I would strongly recommend Alternate A - the NO Action Alternative

The following are detailed comments for your consideration:

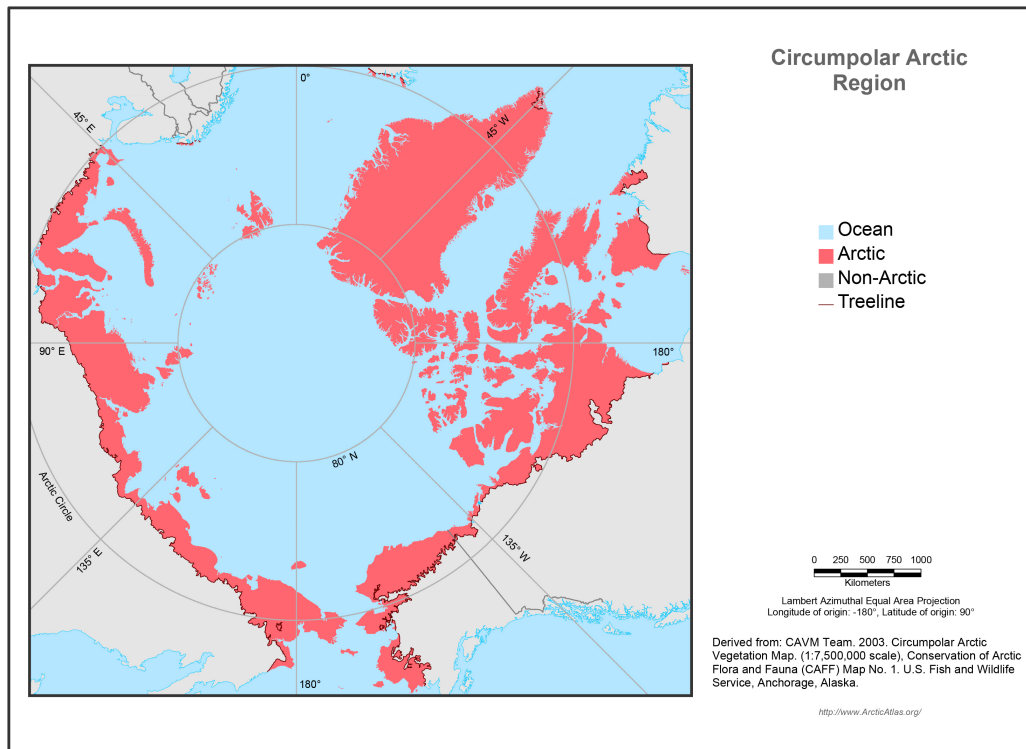
Although this section is titled “in the Arctic” it provides a rather myopic view of what the “Arctic” area includes. It should for analysis of Climate Trends include all waters and land above the Arctic Circle, the entire circumpolar area (see map below), if it is to adequately address climate change concerns in the polar region, of which this project is a part of. This analysis appears to focus more narrowly on just a small section of the Alaskan “Arctic,” and an even smaller portion of the total area in the NPR-A. I am suggesting a more comprehensive approach which could provide for a more meaningful analysis in the impacts and cumulative effects sections, as Arctic warming is not contained within the geo/political boundaries of the State of Alaska nor to the boundaries of the NPR-A nor the project site.

Once again I would like to refer to the Circumpolar Map, included earlier in this document. When concerns are raised about oil development activities in the arctic, permafrost melting, methane release and climate change, it is important to view them in a broad perspective over the entire circumpolar region and over time. Oil development activities in the past are continuing to have a lasting effects on our climate. Actions such as this proposal, will continue to have lasting effects outlasting the actually years it takes to extract the oil.
